P/N: 544-3727

DESCRIPTION		D-SUB WITH 9-PIN MALE CONNECTOR BY FORMING					
製圖	DRAWN	TOLERANCE	品名	050-0009P-F	DATE	版次	REV.
		.X ±0.2	TITLE		02.22.95		A-2
檢圖	CHECK	.XX ±0.1	單位	DWG.NO. 55-0042			
			mm(in)				
認定	APPROVAL	.XXX ±0.05	比例				
		ANGLE ±5°	2:1

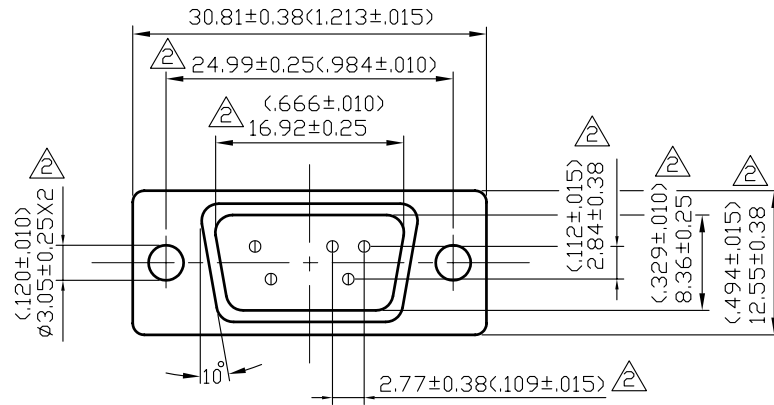
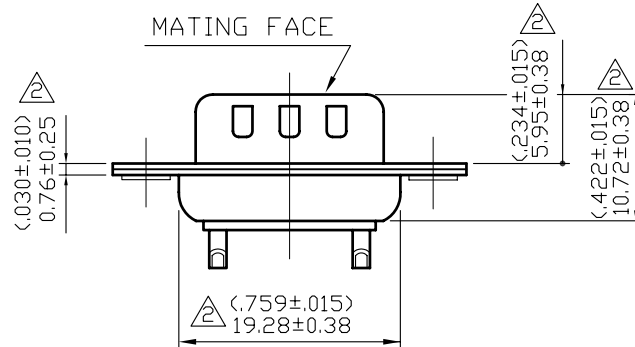
NO	DESCRIPTION	DATE
1	ADD MIS PART NO.	04.01.04
	ADD DESCRIPTION	
	24.99±0.13 → 24.99±0.25	
	16.92±0.13 → 16.92±0.25	
	∅3.05 → ∅3.05±0.25	
	8.36 → 8.36±0.25	
	12.55 REF. → 12.55±0.38	
	2.77 → 2.77±0.38	
	19.28 REF. → 19.28±0.38	10.02.07
	1 → 0.76±0.25	
	(5.97) → 5.95±0.38	
	10.72 REF. → 10.72±0.38	
	11 REF. → 10.72±0.38	
	3.3 REF. → 2.8±0.7	
	2.84 → 2.84±0.38	
	MIS PART NO. → P/N
